Limerick Generating Station, Units 1 and 2
Facility Operating License Nos. NPF-39 and NPF-85
NRC Docket Nos. 50-352 and 50-353

Subject: Response to Request for Additional Information Concerning Relief
Requests Associated with the Second Inservice Inspection (ISI) Interval

**Response to Request for Additional Information
Regarding Relief Requests Associated With the
Second Inservice Inspection Interval**

Limerick Generating Station, Units 1 and 2

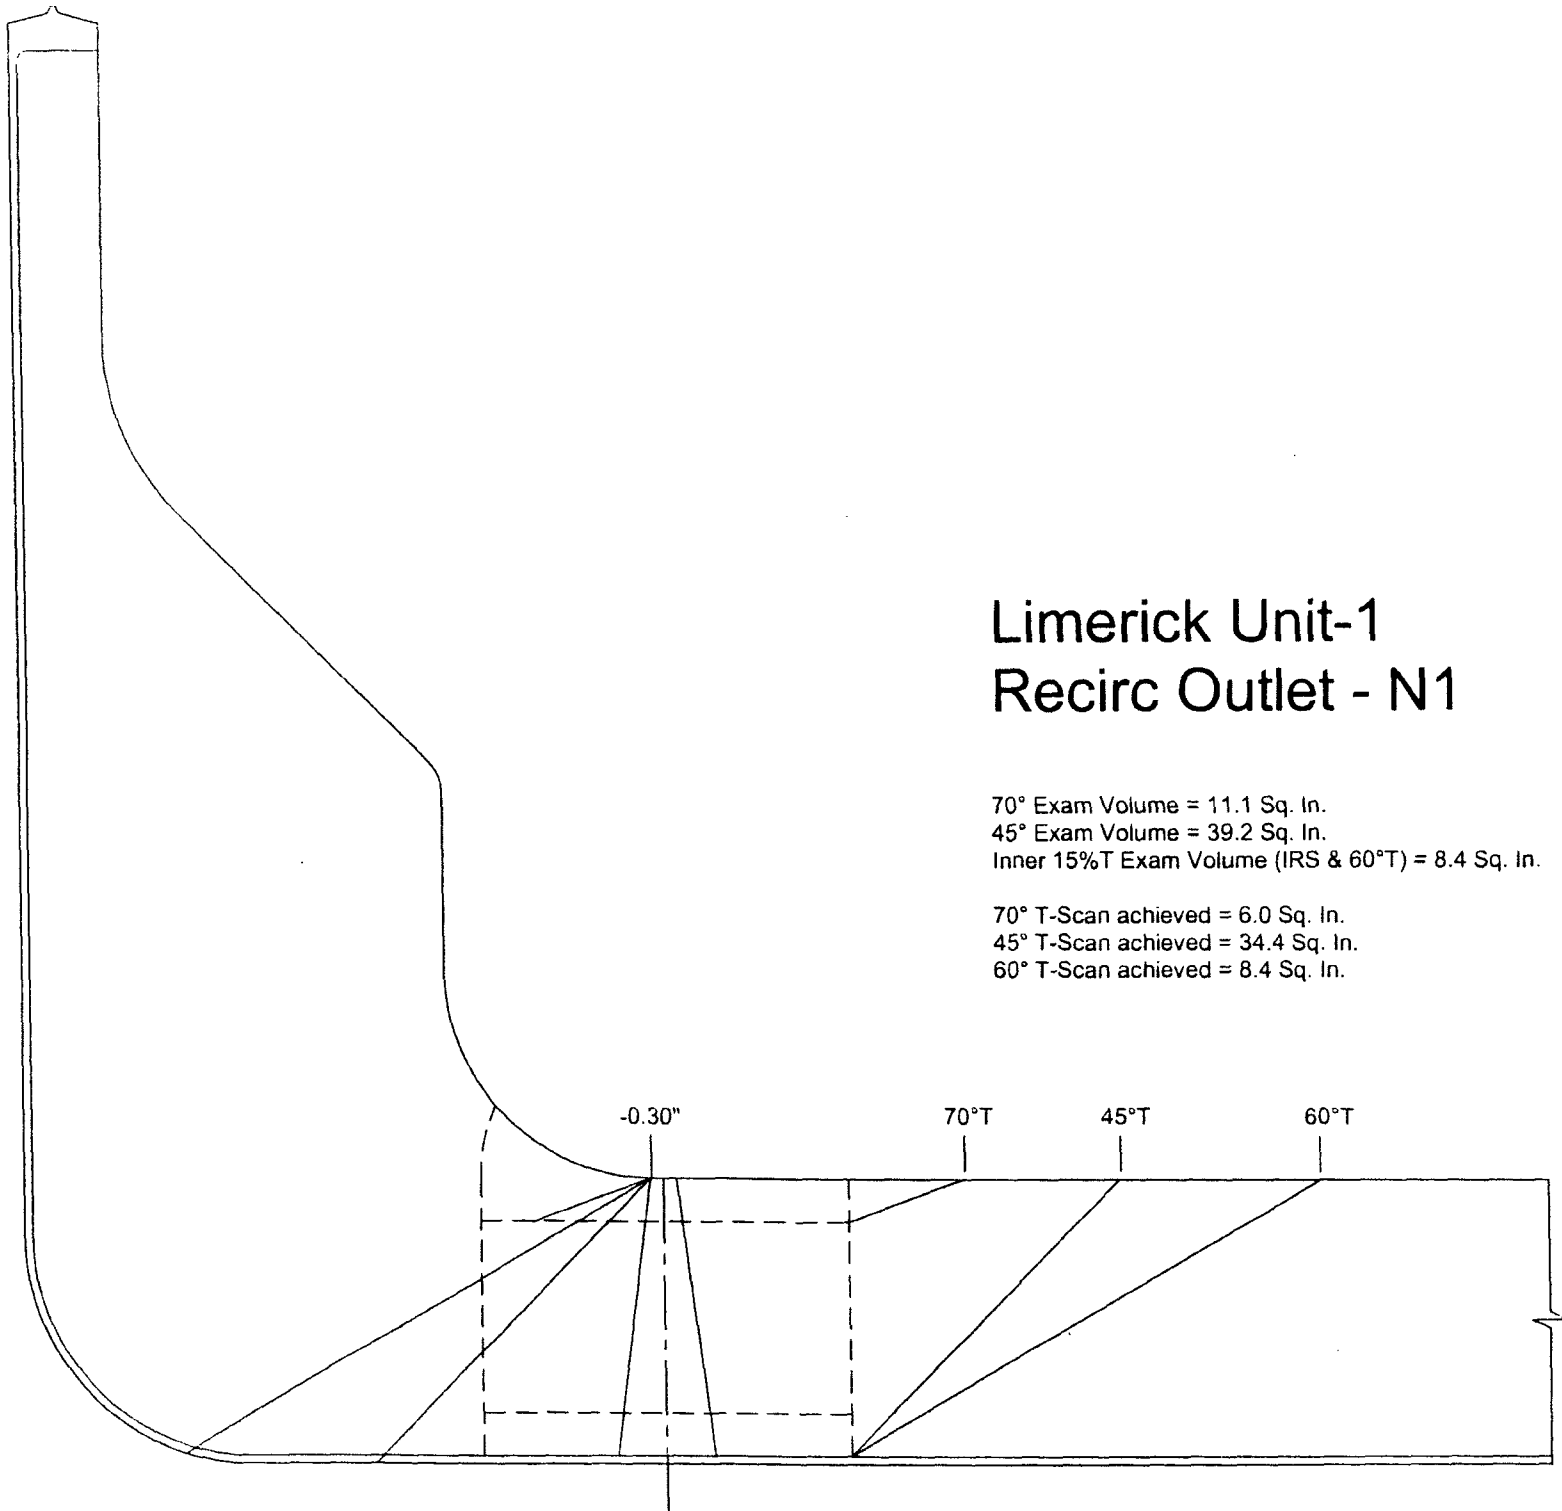
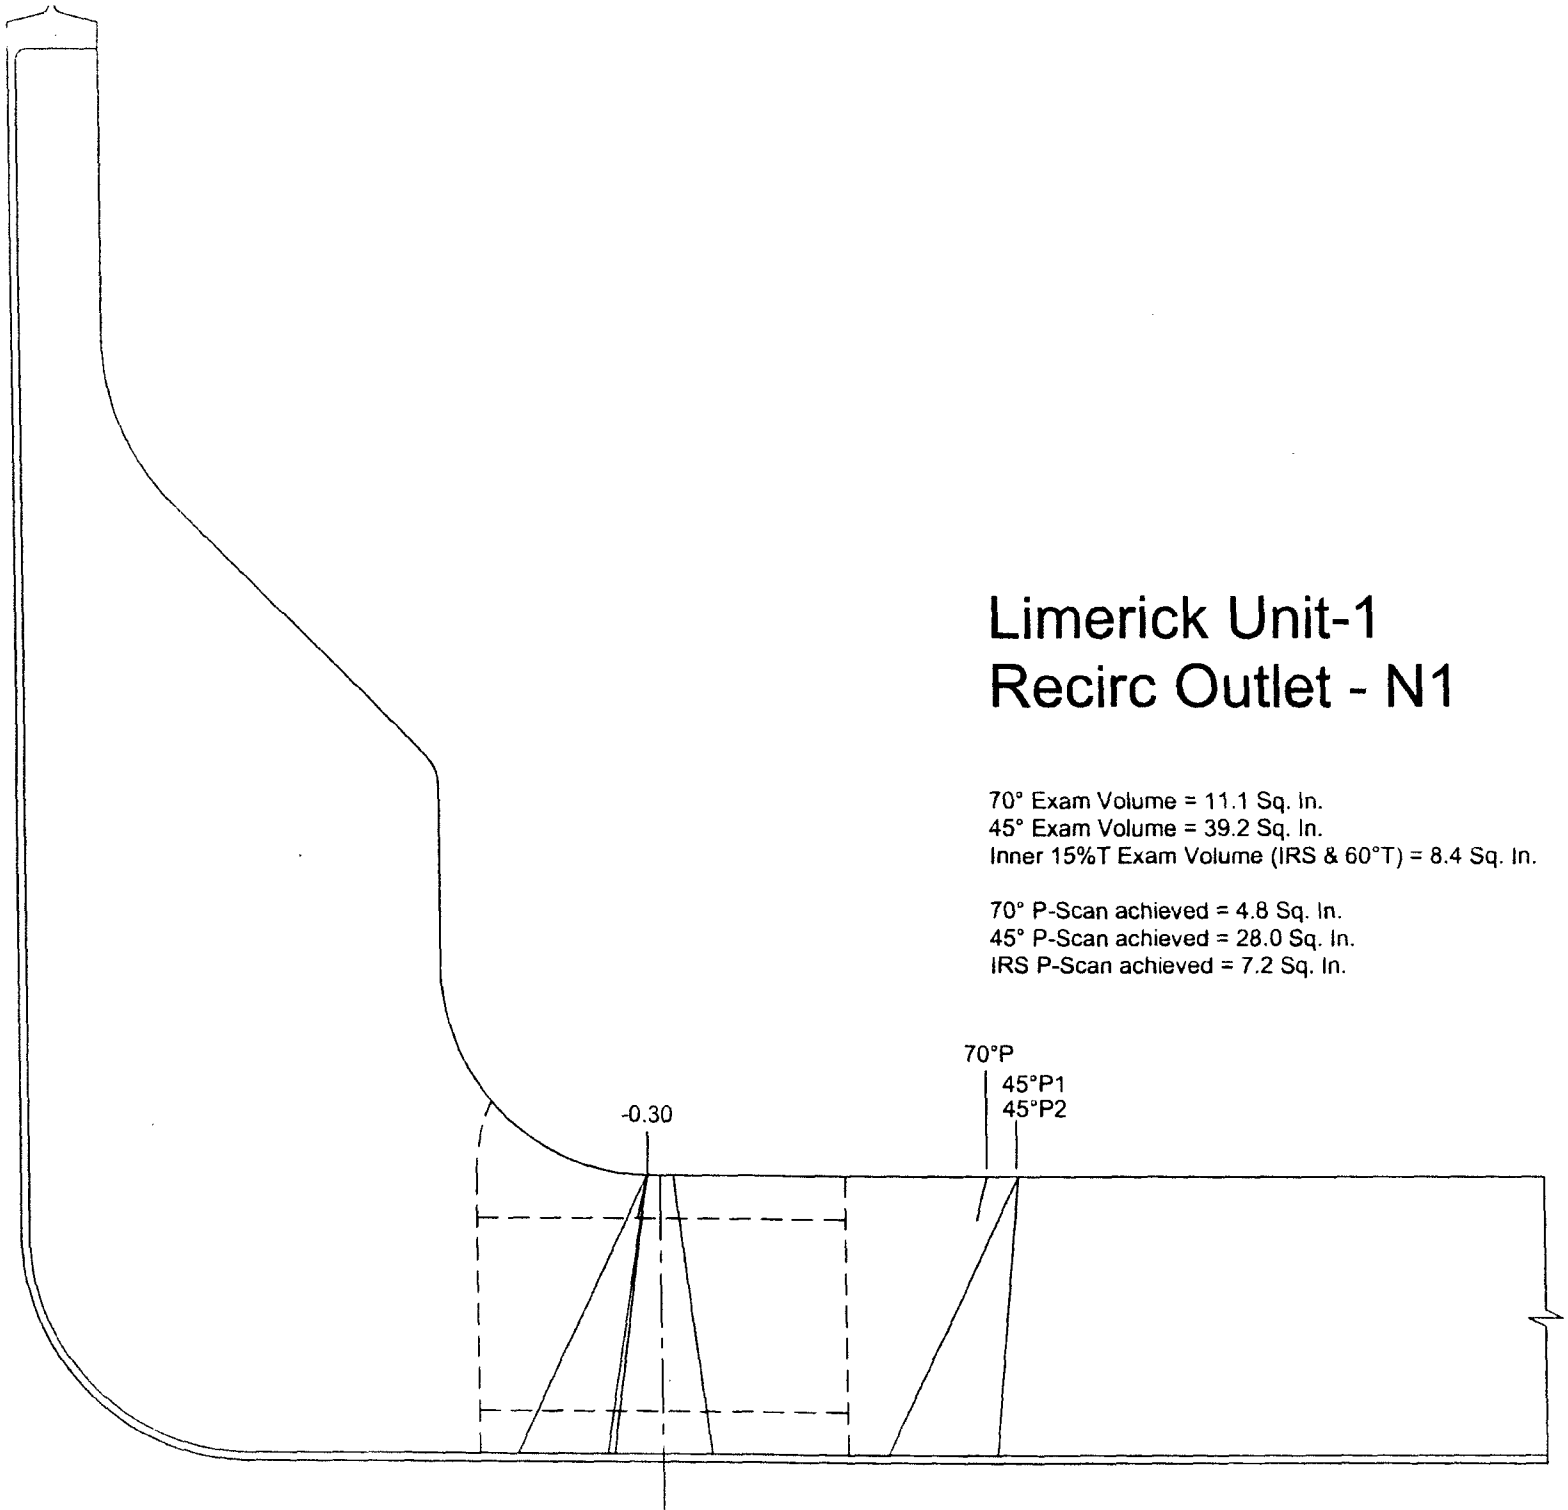
The completed examination was limited to 75.6% Code required coverage due to the design of the reactor vessel nozzle. The following coverage calculation sheet and the drawings contain the limitations. No unacceptable indications were noted. A system pressure test was also completed with no unacceptable indications observed.

Comments: A - Scanned 360 deg., Scanning limited due to nozzle configuration.

Limerick 1
Recirculation Outlet
N1B Nozzle

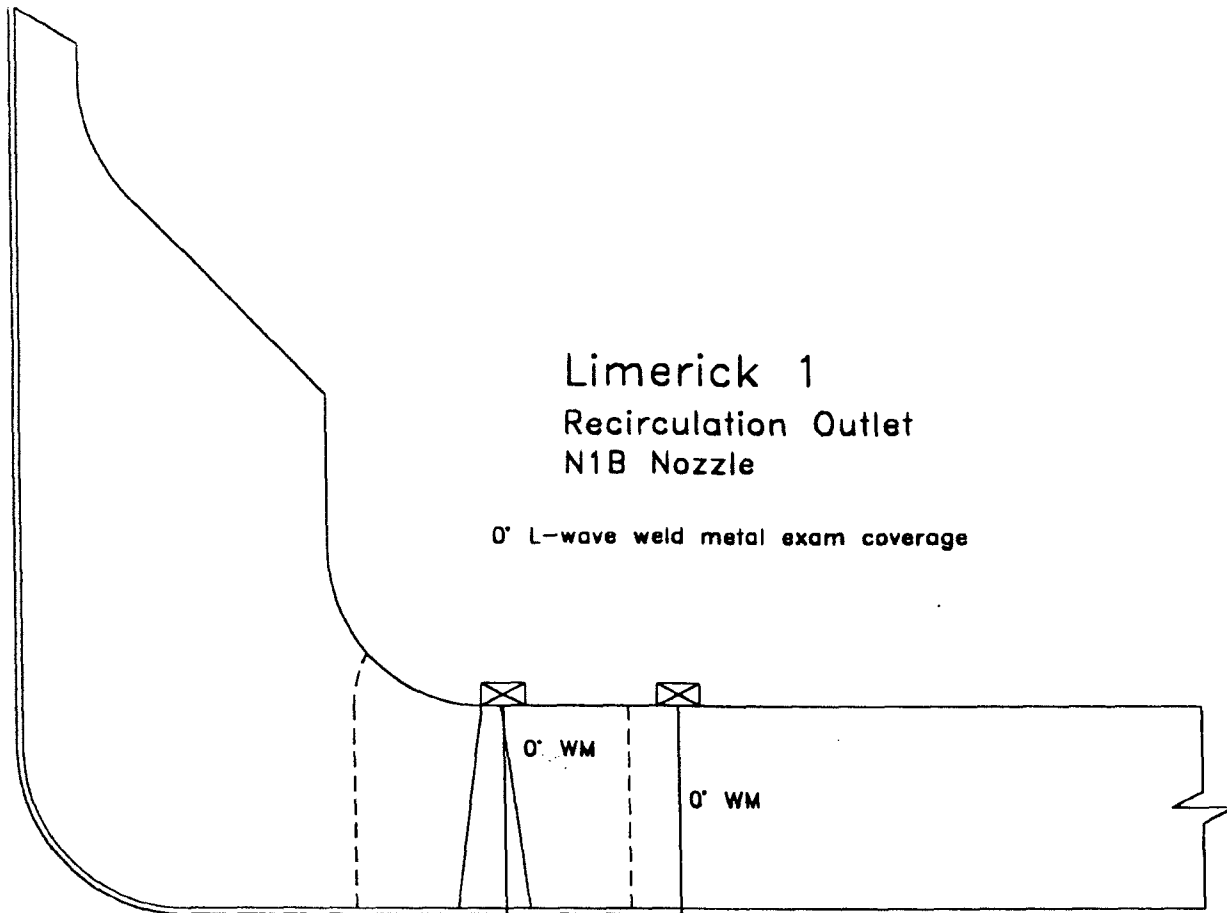
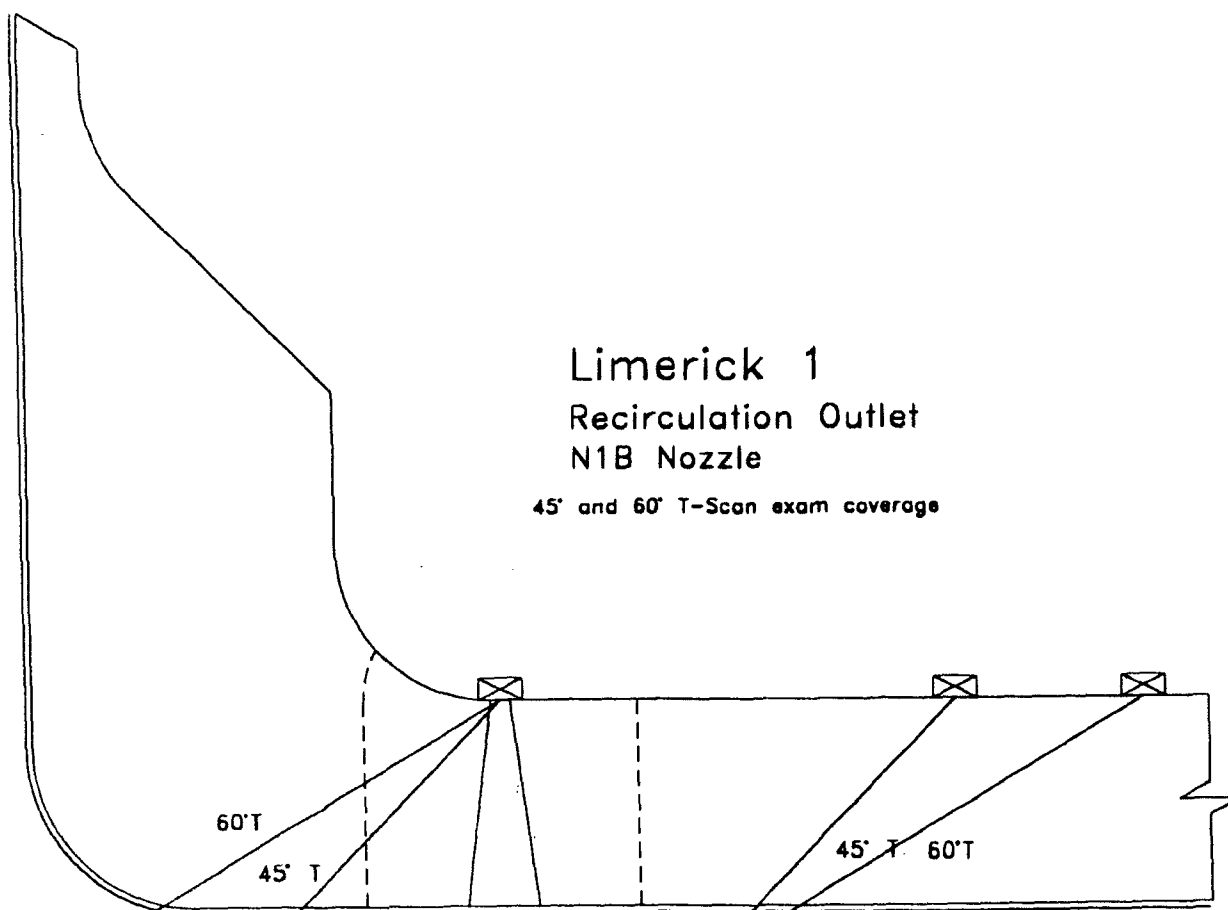
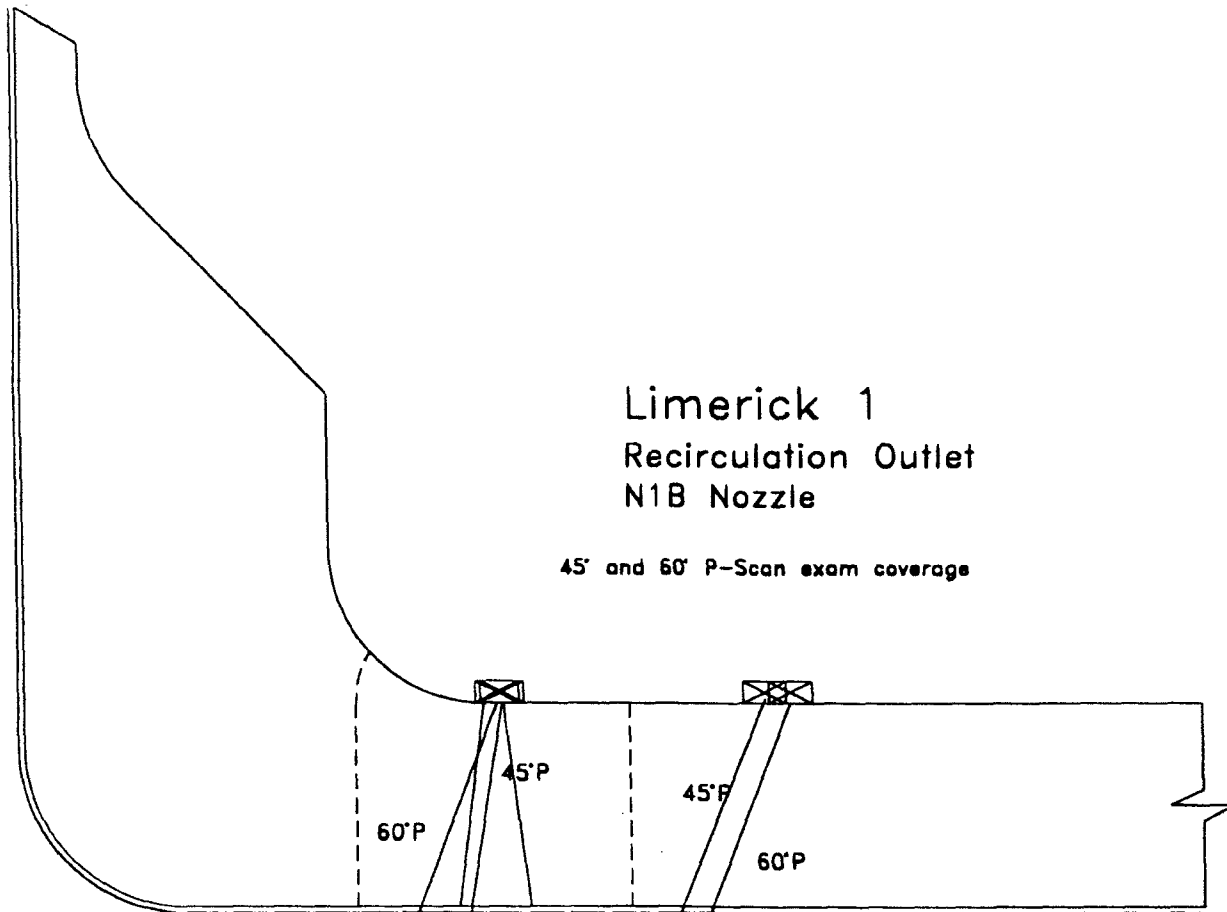
The completed examination was limited to 60% Code required coverage due to the design of the reactor vessel nozzle. The following coverage calculation sheet and the drawings contain the limitations. No unacceptable indications were noted. A system pressure test was also completed with no unacceptable indications observed.
